GLENEAGLE
 SUBDIVISION FIL #2

**DRAINAGE, GRADING &
 EROSION CONTROL
 PLAN**

VR-18-018

ROADWAY DETAILS

MODIFIED TYPE 13 INLET
NOT TO SCALE

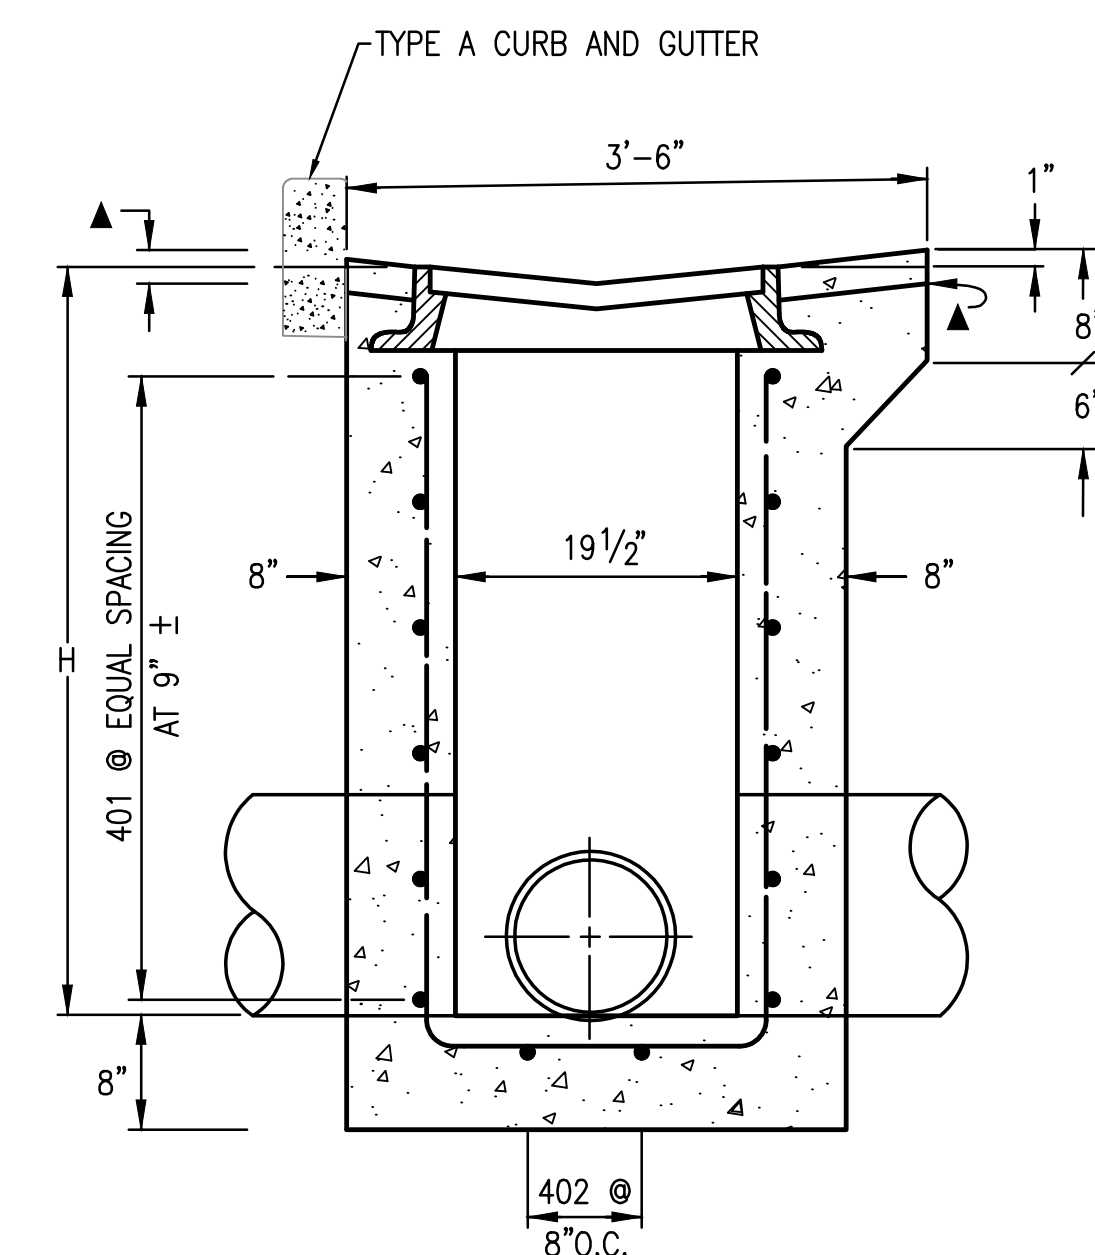
Provide a curb opening inlet. Type R, or propose a combination inlet such as a Denver D-16 design. The Modified Type 13 is for a inverted crown type application.
